site preparation and demolition plan

ADDITIONS AND ALTERATIONS TO
DEAN B. ELLIS LIBRARY
ARKANSAS STATE UNIVERSITY
STATE UNIVERSITY, ARKANSAS

MECHANICAL SITE PLAN

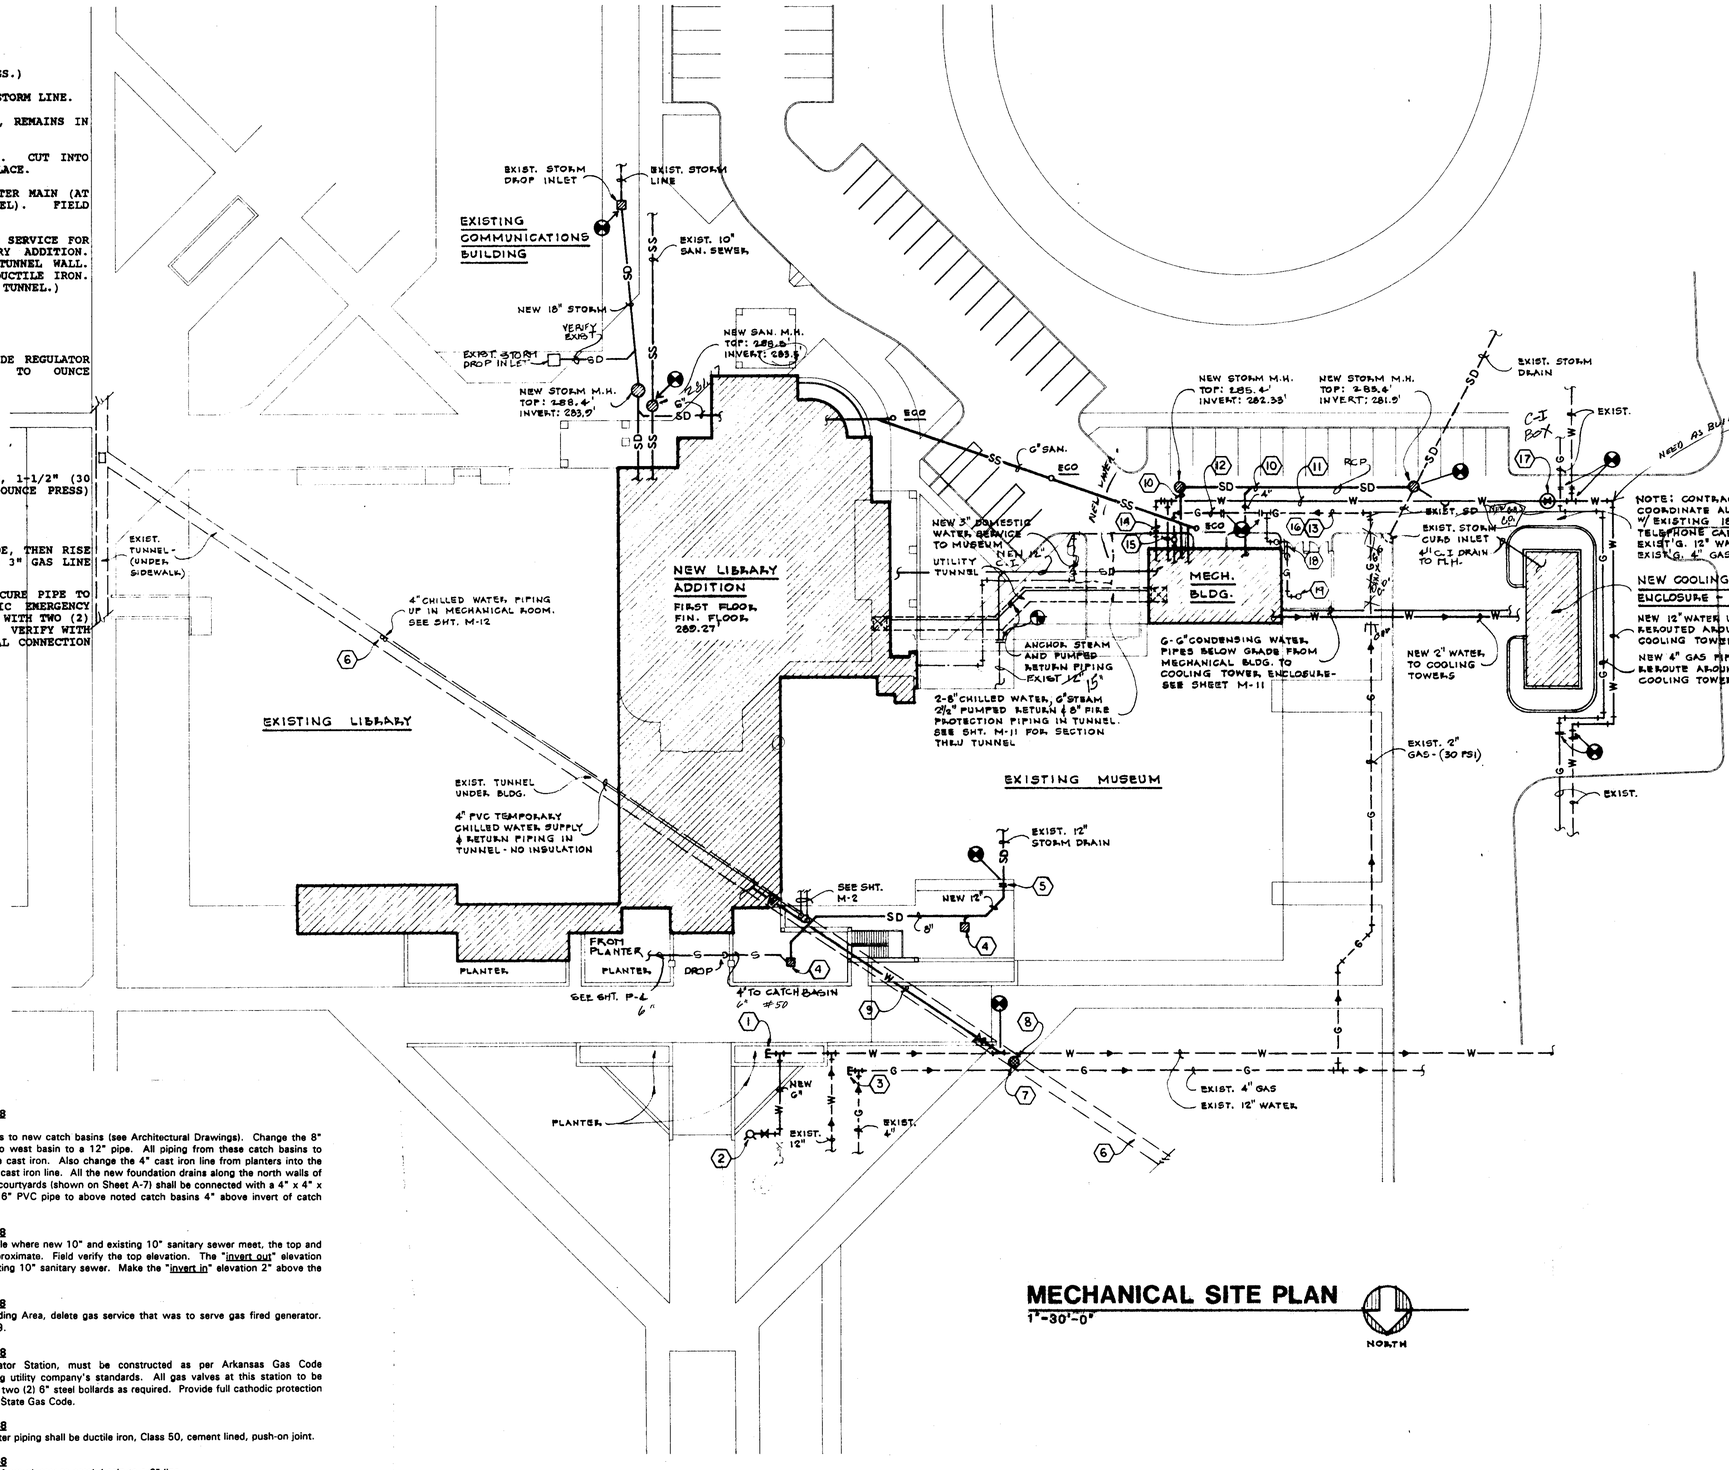
Note #4 this sheet refers to new catch basins (see Architectural Drawings). Change the 8" storm from east basin to west basin to a 12" pipe. All piping from these catch basins to existing 12" line shall be cast iron. Also change the 4" cast iron line from planters into the east catch basin to a 6" cast iron line. All the new foundation drains along the north walls of New Addition, planters, courtyards (shown on Sheet A-7) shall be connected with a 4" x 4" x 6" wye and run a solid 6" PVC pipe to above noted catch basins 4" above invert of catch basin, if possible.

46. **DRAWINGS, SHEET MP-8**
    The new sanitary manhole where new 10" and existing 10" sanitary sewer meet, the top and invert elevations are approximate. Field verify the top elevation. The "invert out" elevation will be same as the existing 10" sanitary sewer. Make the "invert in" elevation 2" above the existing line.

47. **DRAWINGS, SHEET MP-8**
    At new Mechanical Building Area, delete gas service that was to serve gas fired generator. Delete Note #18 and #19.

48. **DRAWINGS, SHEET MP-8**
    Note #12, Gas Regulator Station, must be constructed as per Arkansas Gas Code requirements and serving utility company's standards. All gas valves at this station to be lubricated type. Provide two (2) 6" steel bollards as required. Provide full cathodic protection as required by Arkansas State Gas Code.

49. **DRAWINGS, SHEET MP-8**
    All new below grade water piping shall be ductile iron, Class 50, cement lined, push-on joint.

50. **DRAWINGS, SHEET MP-8**
    Change 4" cast iron line from planter to catch basin to a 6" line.

MECHANICAL & ELECTRICAL ROOF PLAN

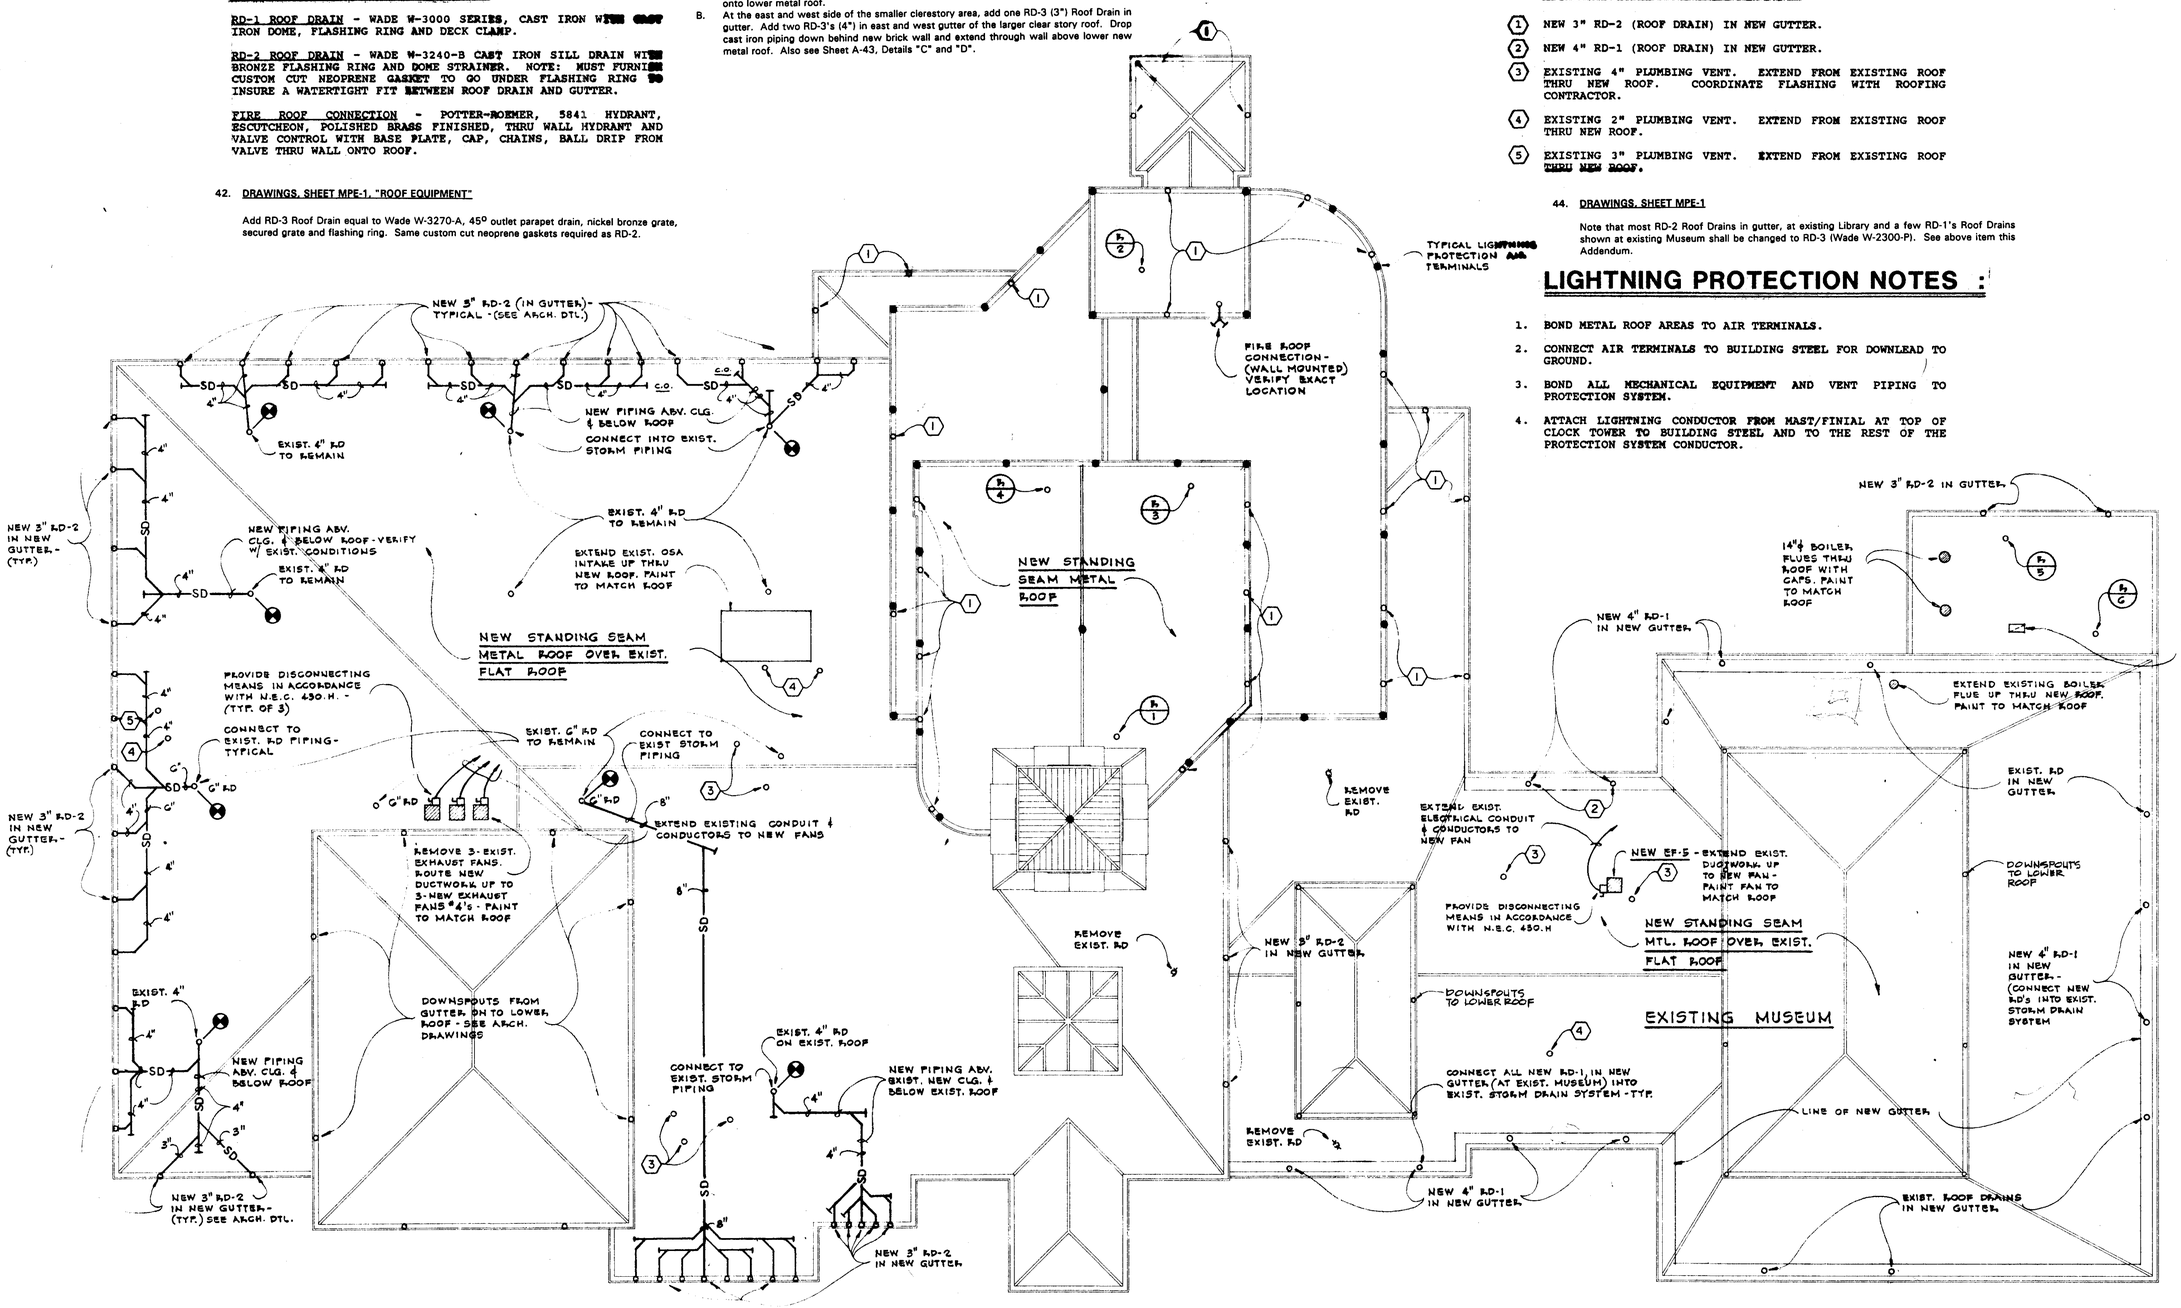
42. DRAWINGS, SHEET MPE-1, "ROOF EQUIPMENT"

B. At the east and west side of the smaller clerestory area, add one RD-3 (3") Roof Drain in gutter. Add two RD-3's (4") in east and west gutter of the larger clear story roof. Drop cast iron piping down behind new brick wall and extend through wall above lower new metal roof. Also see Sheet A-43, Details "C" and "D".

second floor framing plan part B

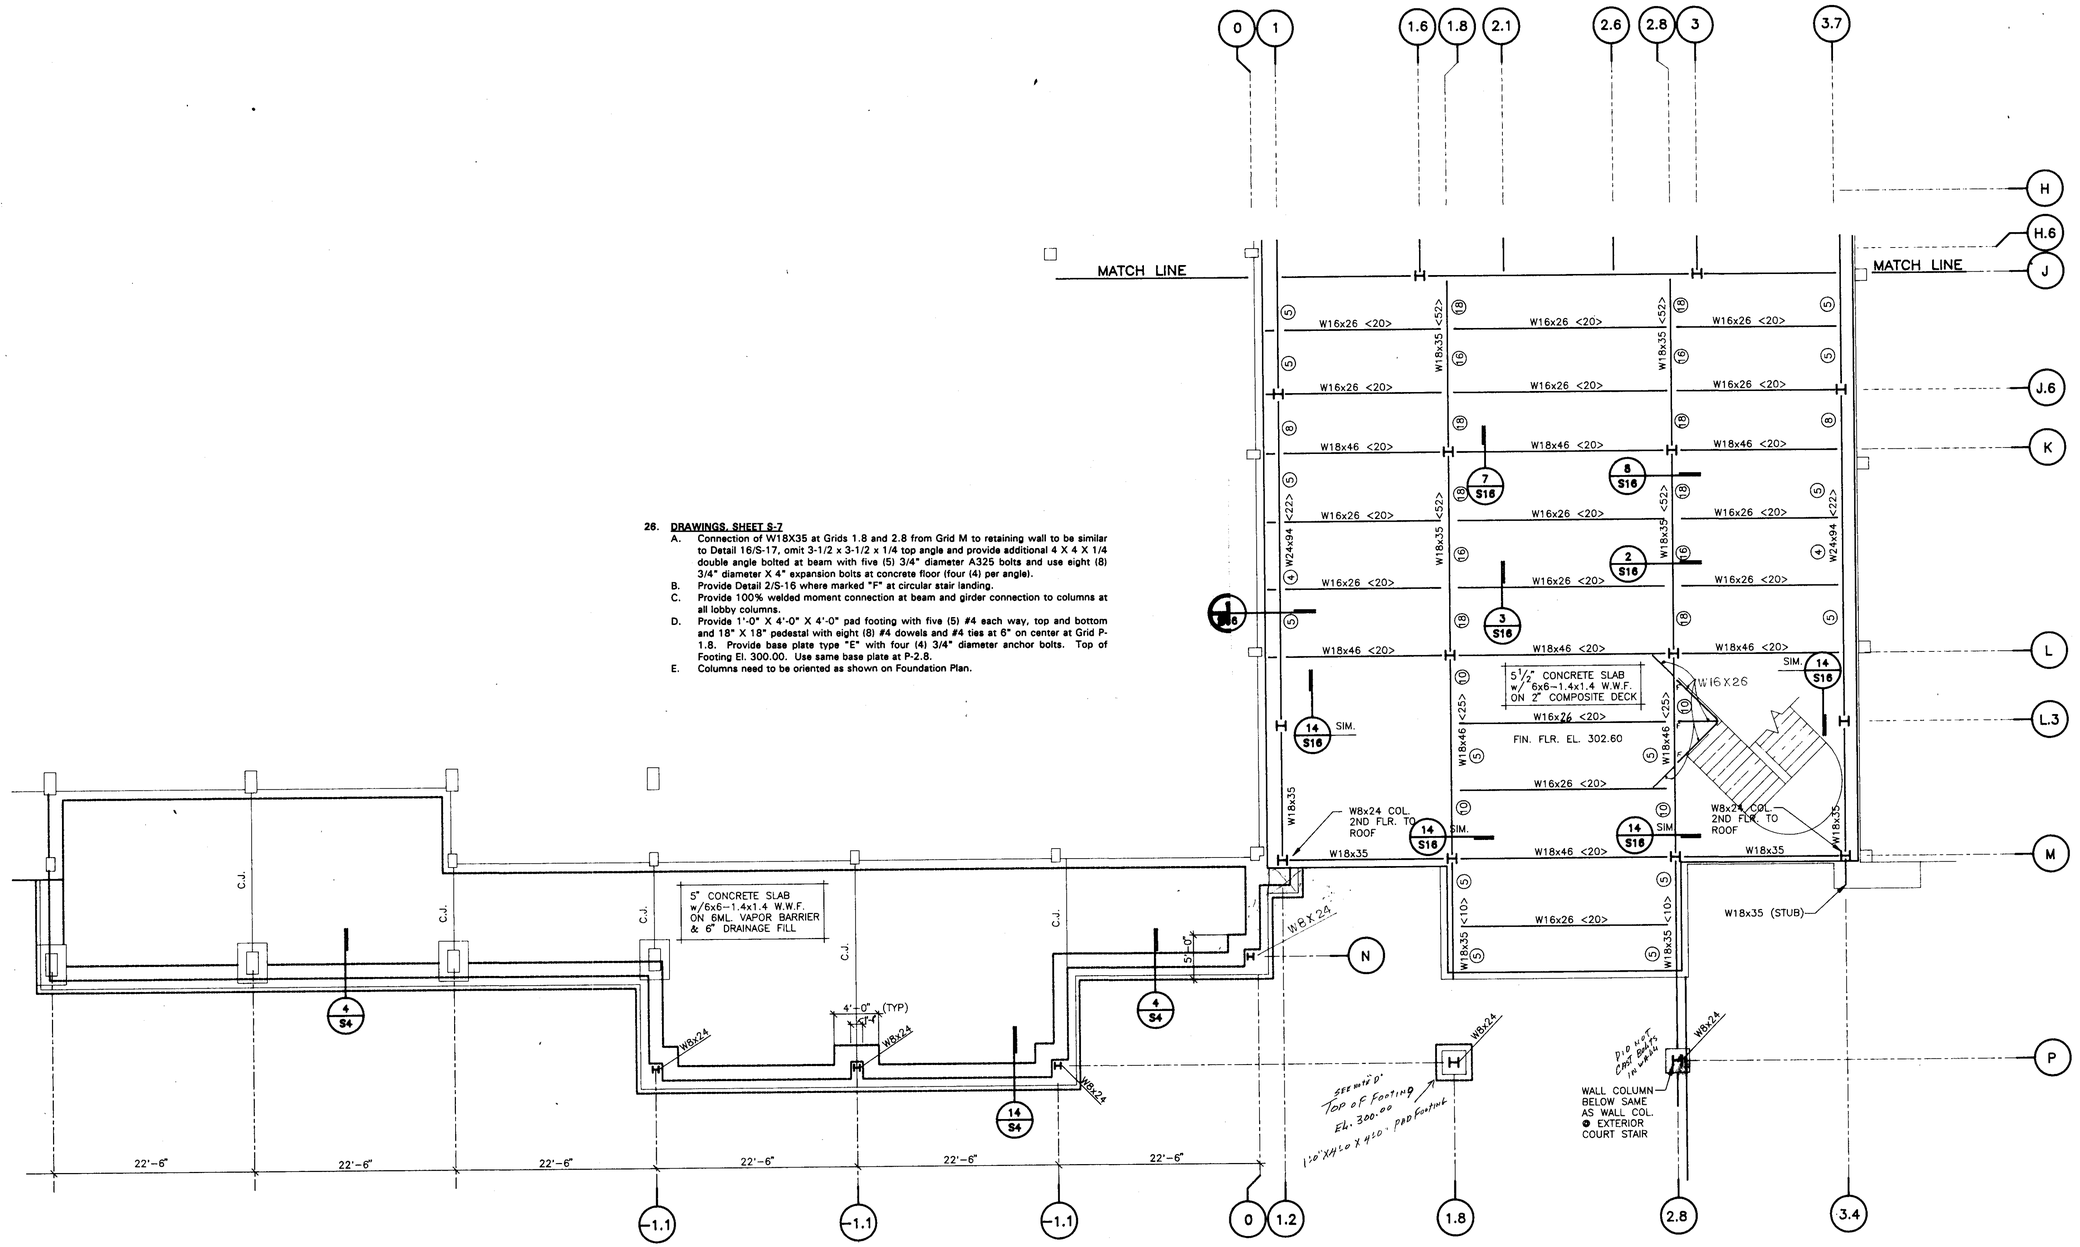
26. DRAWINGS, SHEET S-7

A. Connection of W18X35 at Grids 1.8 and 2.8 from Grid M to retaining wall to be similar to Detail 16/S-17, omit 3-1/2 x 3-1/2 x 1/4 top angle and provide additional 4 X 4 X 1/4 double angle bolted at beam with five (5) 3/4" diameter A325 bolts and use eight (8) 3/4" diameter X 4" expansion bolts at concrete floor (four (4) per angle).

B. Provide Detail 2/S-16 where marked "F" at circular stair landing.

D. Provide 1'-0" X 4'-0" X 4'-0" pad footing with five (5) #4 each way, top and bottom and 18" X 18" pedestal with eight (8) #4 dowels and #4 ties at 6" on center at Grid P-1.8. Provide base plate type "E" with four (4) 3/4" diameter anchor bolts. Top of Footing El. 300.00. Use same base plate at P-2.8.

E. Columns need to be oriented as shown on Foundation Plan.
